MANDATORY SERVICE BULLETIN

DATE: September 21, 2007 Service Bulletin No. 576
Engineering Aspects are
FAA Approved

SUBJECT: Reprint of Teledyne Continental Ignition Systems Service Bulletin No. SB633A

**SUBJECT: TWO-WIRE MAGNETO TACHOMETER
BREAKER CONTACT (POINTS) ASSEMBLY
PART NUMBER 10-400507**

FIGURE 1
P/N 10-361639 PHENOLIC BUSHING INSPECTION

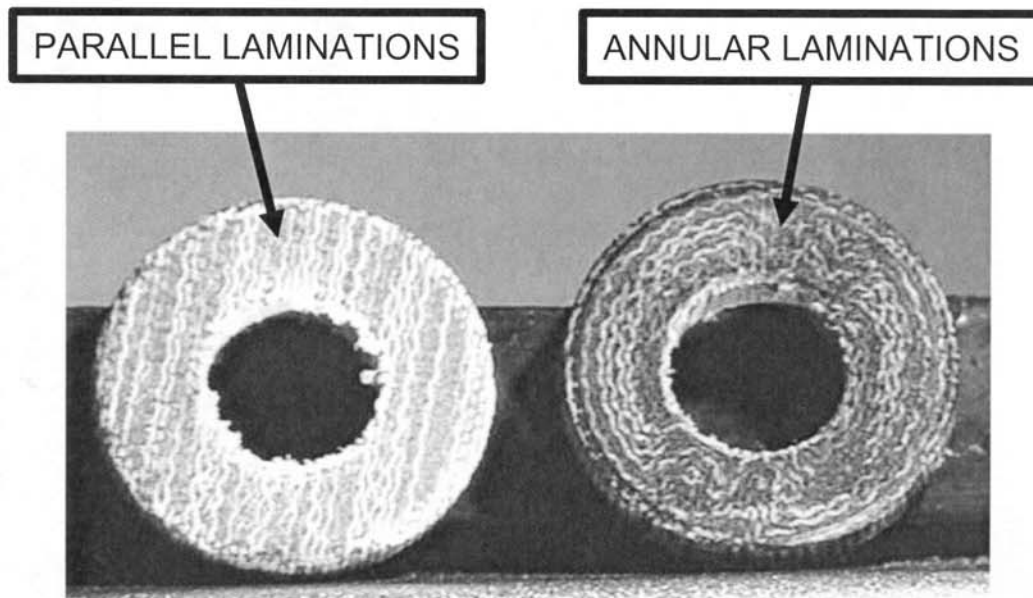
- (a) Inspect the P/N 10-361639 tachometer insulating bushings for cracks, crushing or other damage. Current bushings use phenolic material that is laminated in an annular (circular) pattern. (Reference Figure 1)

- (b) Any bushing found to have parallel laminations as shown in Figure 2 must be replaced before further service.
 - (c) Set tachometer contacts to .016 - .022 clearance on the high lobe of the cam. Apply 8-10 inch-pounds torque to the retaining screws.

- (d) Visually inspect the P/N 10-361639 phenolic insulating bushings for damage after torque application. Any damaged bushings must be replaced before further service.

FIGURE 2
BREAKER COMPARTMENT ASSEMBLY AND WIRING
WIRE COLORS IN FIGURE 2 ARE FOR ILLUSTRATION OF ROUTING ONLY
AND DO NOT INDICATE ACTUAL WIRE COLORS.

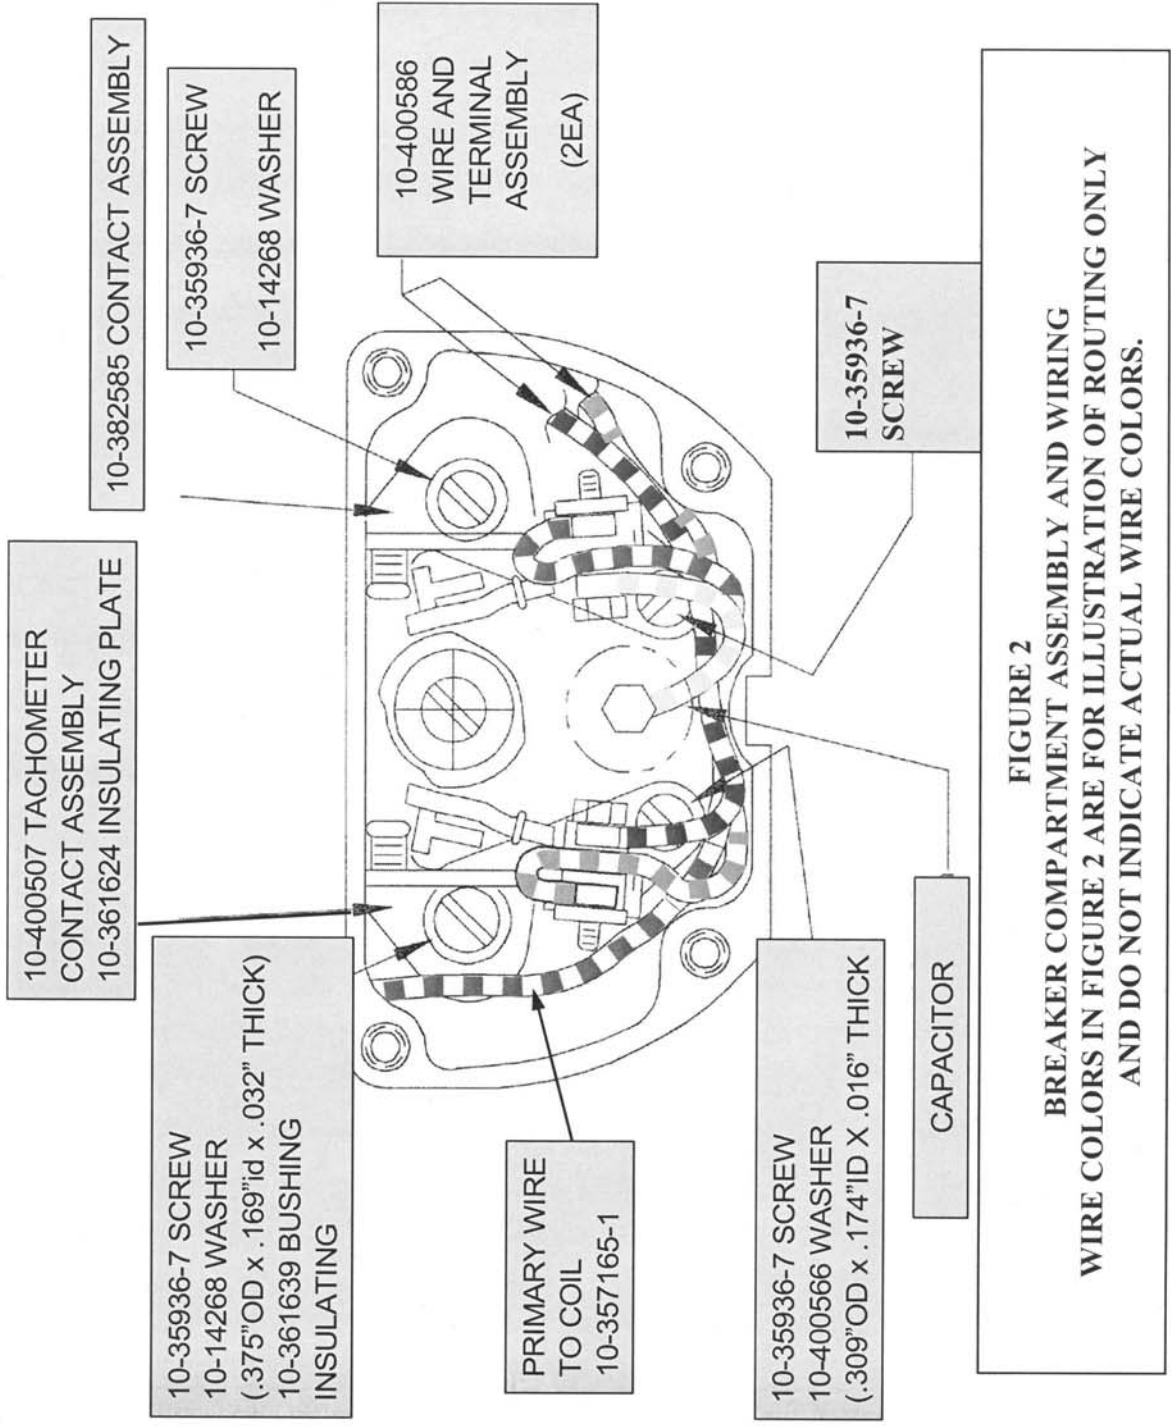
1. Parts Assembly: Figure 2 depicts the correct current configuration of parts, assemblies and wiring in the magneto breaker compartment of the affected magnetos.

- (e) Washer P/N 10-14268 is used under the screw at the adjusting slot in the P/N 10-400507 tachometer contact assembly. The washer is thicker and wider to spread the clamping load evenly to the bushing that bridges the slot.

- (f) Washer P/N 10-400566 is used under the screw at the pivot hole in the P/N 10-400507 tachometer contact assembly. This washer is smaller to ensure electrical insulation from the tachometer assembly. The insulating bushing is supported on all sides by the breaker support.

2. The breaker compartment features four wires that must be assembled properly to ensure continued reliable service: the coil primary wire, the two tachometer wires, and the capacitor wire. (See FIGURE 2.) Whenever access allows, inspect wires to ensure that they are free of cuts or chafing damage. Wires must be routed as shown in FIGURE 2 to ensure that they do not interfere with the rotating cam and associated parts during operation, and to ensure that no wire is pinched between the breaker cover and distributor housing at assembly. Any excess coil wire may be protected by bending it away from the cam. Coil and capacitor wires feature insulation that is relatively soft. Indentations on the insulation on these parts are normal and expected. Any exposed wire strands is cause for replacement. Replace damaged parts as necessary. The two tachometer wires use a short length of tubing as an assembly aid: the position of the tubing at

assembly is unimportant. Either tachometer wire may pass through either hole in the bushing in the breaker compartment cover.

FIGURE 3

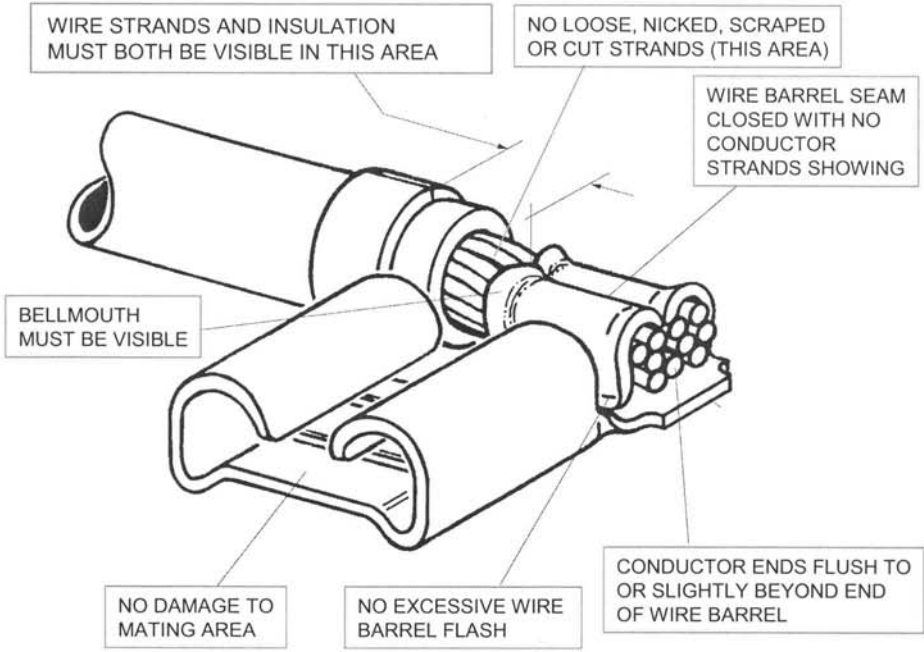
3. Whenever access allows, inspect the wiring terminals (Flag Terminals) for integrity as shown in Figure 3.
4. Hi-Pot insulation integrity test.
 - (a) As applicable, disconnect magneto tachometer wires from all airframe circuits in accordance with airframe manufacturer's instructions.

FIGURE 4

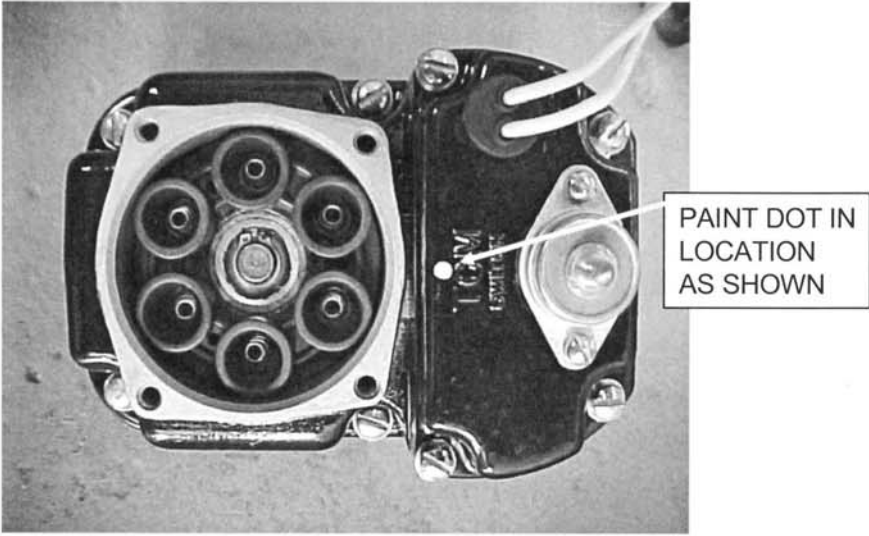
COMPLIANCE: All affected magnetos must be inspected and maintained per the instructions contained in this bulletin at each magneto overhaul, 500 hour inspection, each time the magneto tachometer breaker points are serviced or replaced, or at any time a component that utilizes the magneto tachometer breaker points exhibits abnormal operation. Additionally, any affected part number magneto between serial numbers D05DA001 to D06JA001 or between serial numbers E05DA001 to E06JA001 must be inspected per this service bulletin at the next scheduled maintenance visit. (See Figure 4 for initial compliance marking requirements applicable to above listed serial number magnetos only.)

Initial compliance identification. Applicable to designated serial number range only.
NOTE: Initial compliance does not preclude recurring compliance performance in accordance with the recurring inspection requirements of this bulletin.
